DESIGN APPROVAL NOTIFICATION

MAJOR WORKS (WATER RETICULATION)

(a) Application reference: 22-PNT-60566

Document title / Prepared By	Drawing No.	Date	Amendments
Water Reticulation Cover Sheet	9732 C500	2/9/2022	Yes
Water Reticulation Sections	9732 C510	2/9/2022	Yes
Water Reticulation Plan	9732 C520	2/9/2022	No

PROJECT TITLE: **PROPOSED SUBDIVISION**
174 ADARE ROAD, ADARE, QLD 4343
STAGE 1
DRAWING TITLE: **WATER RETICULATION COVER SHEET**

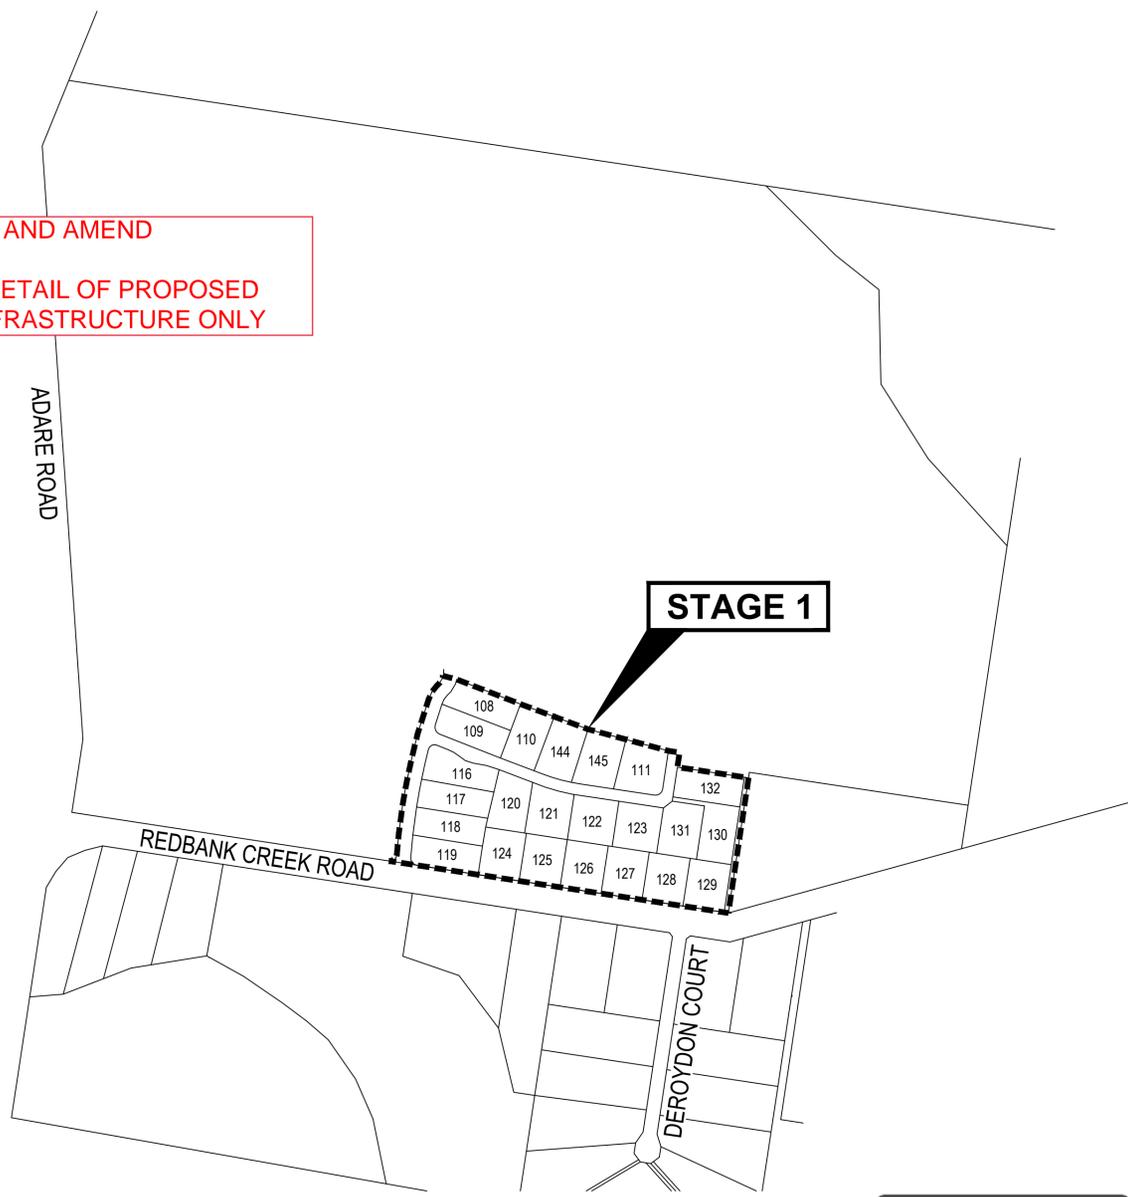
REVIEW AND AMEND
SHOW DETAIL OF PROPOSED NEW INFRASTRUCTURE ONLY
